Docket No. 50-261

Carolina Power & Light Company
ATTN: Mr. E. E. Utley, Vice President
Bulk Power Supply Department
336 Fayetteville Street
Raleigh, North Carolina 27602

Change No. 24
License No. DPR-23

CHANGE NO. 24 TO THE TECHNICAL SPECIFICATIONS

STEAM GENERATOR LEAKRATE LIMIT

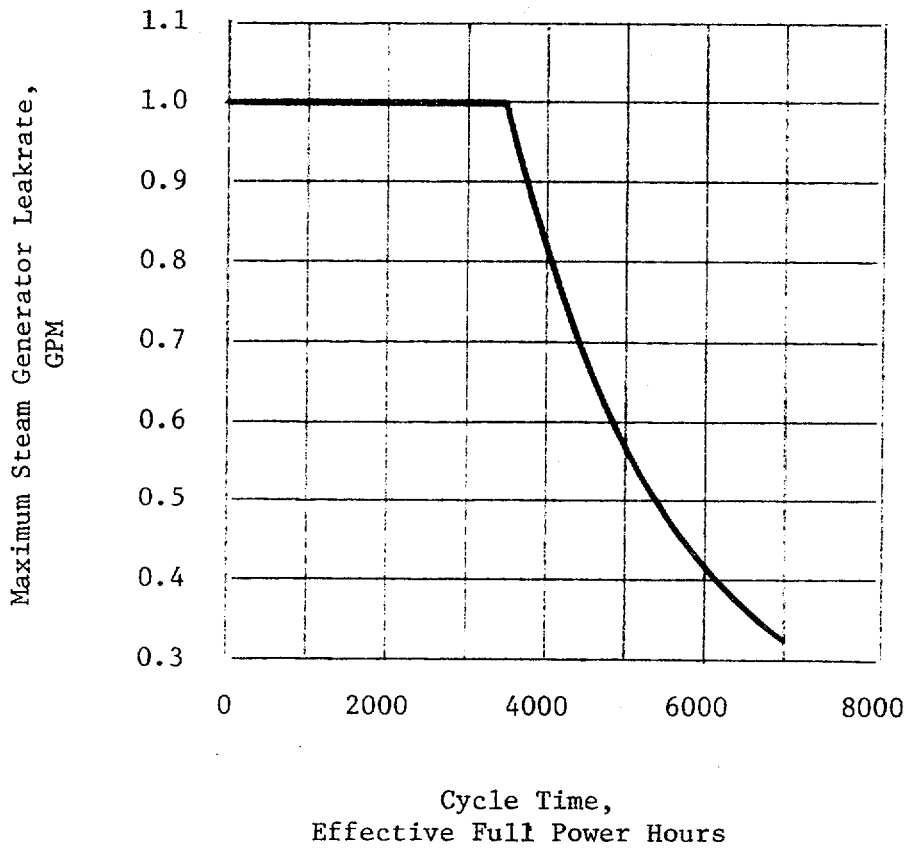
- 3.1.5.3 If the primary to secondary leakage in a steam generator exceeds the limit in Figure 3.1-4, the reactor shall be placed in the hot shutdown condition within 8 hours utilizing normal operating procedures. If the leakage exceeds this limit for 24 hours, the reactor shall be placed in the cold shutdown condition utilizing normal operating procedures.

FIGURE 3.10-1

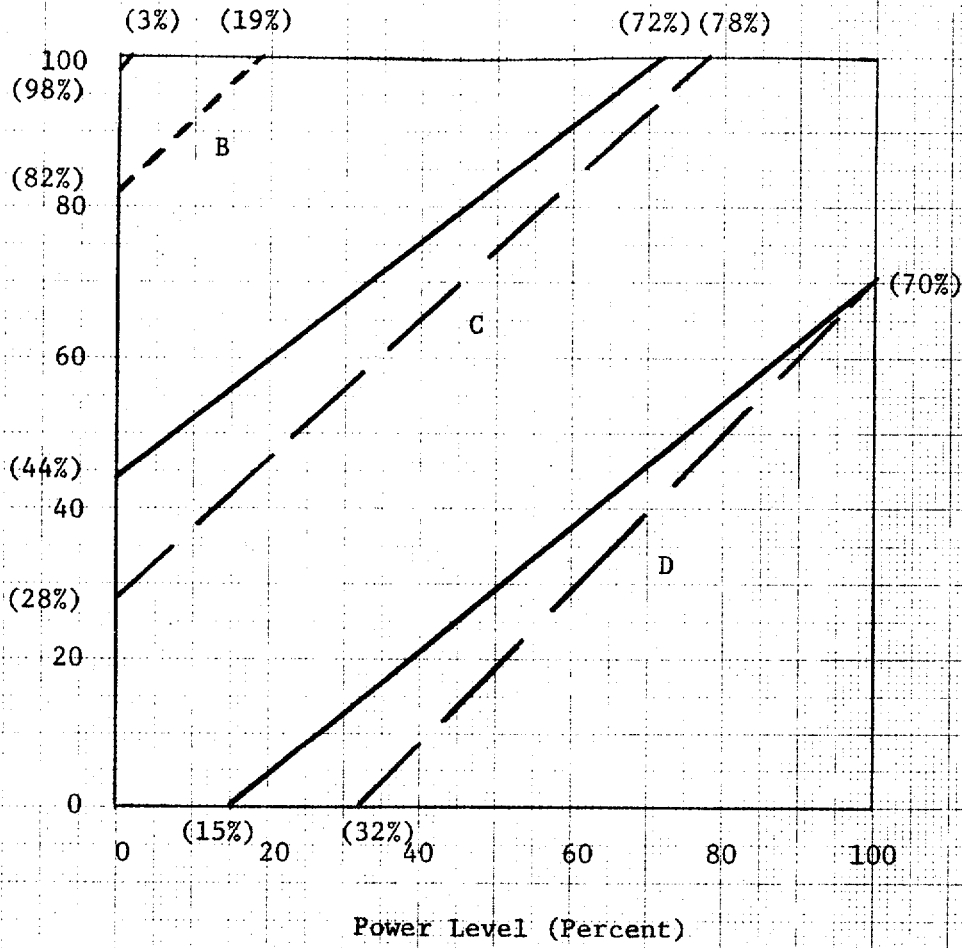
3.10.1.3 When the reactor is critical, except for physics tests and full length control rod exercises, the control rods shall be no further inserted than the limits shown by the solid lines on Figure 3.10-1 for 3 loop or 2 loop operation.

3.10.1.4 After 50% of the second and subsequent cycles as defined by burnup, the limits shall be adjusted as a linear function of burnup toward the end-of-core life values as shown by the dotted lines on Figure 3.10-1.

FIGURE 3.10-3

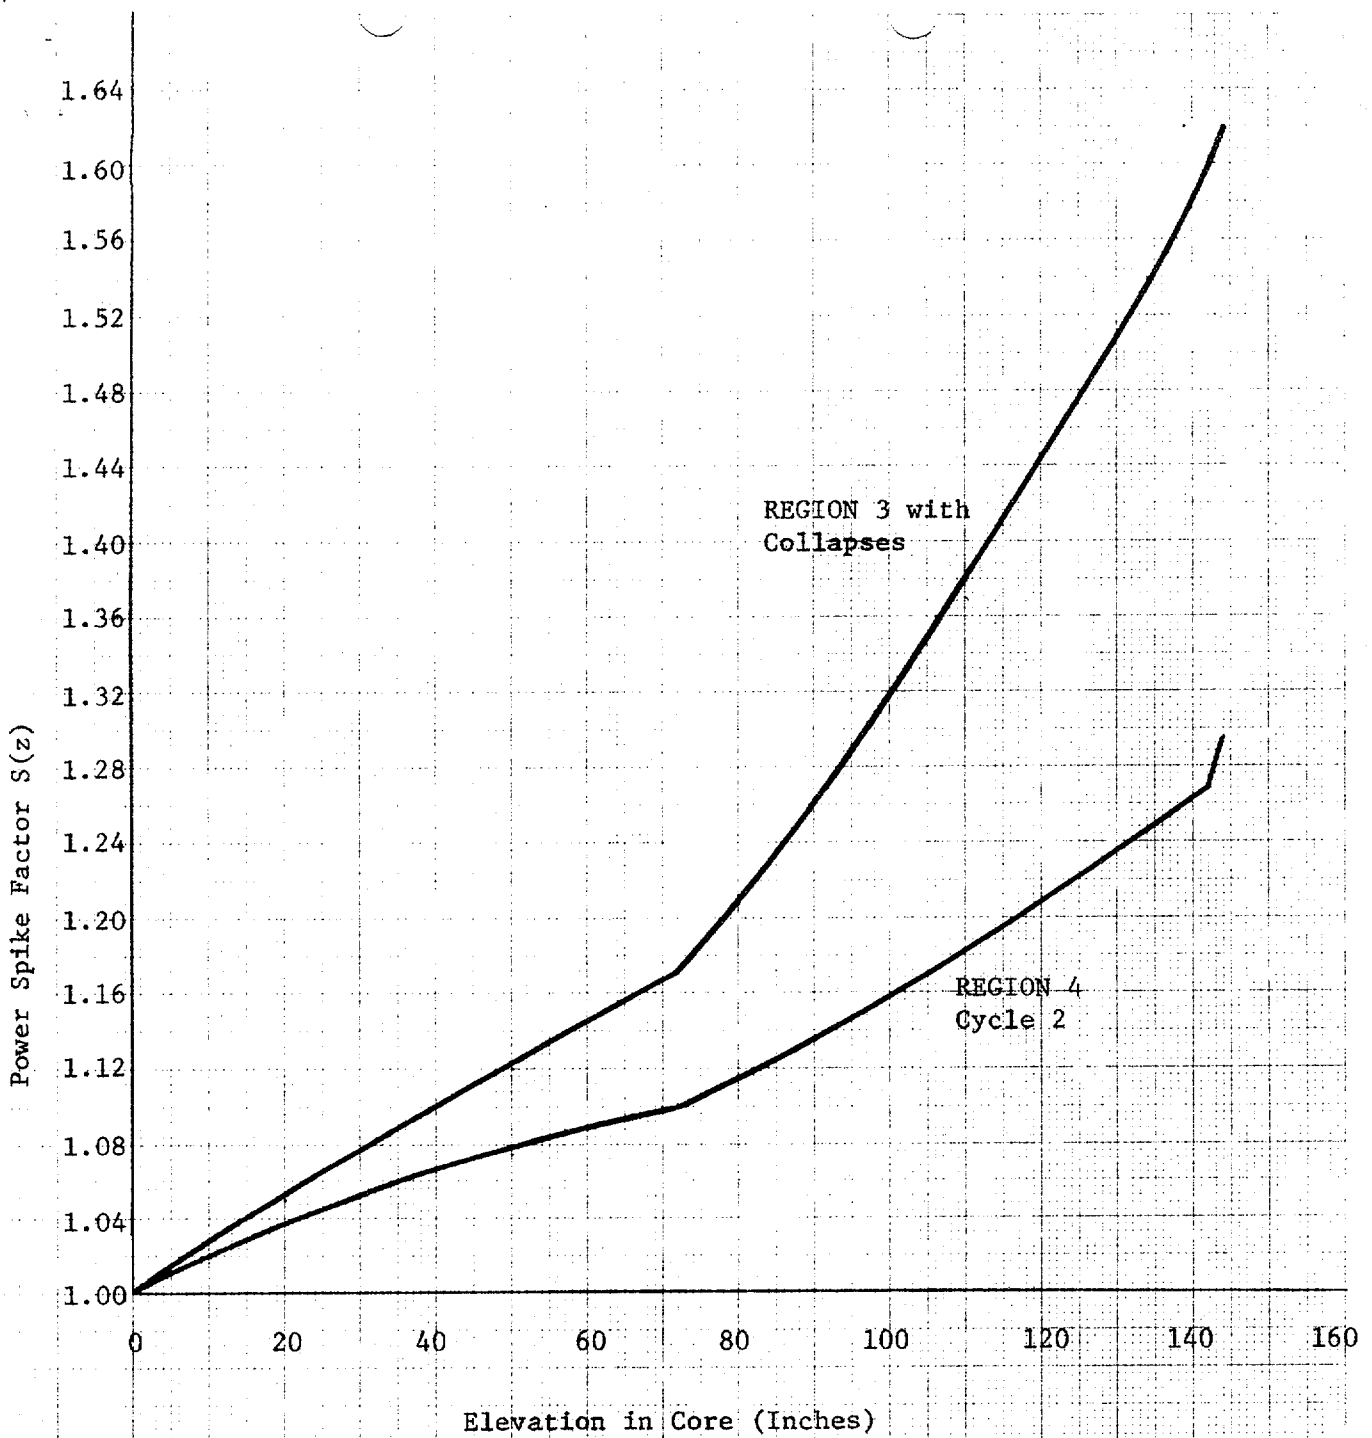
The measured value of F_q^N must be additionally corrected by including a penalty as shown in Figure 3.10-3 (at the appropriate core location) to account for fuel densification effects before comparison with the limiting value above.
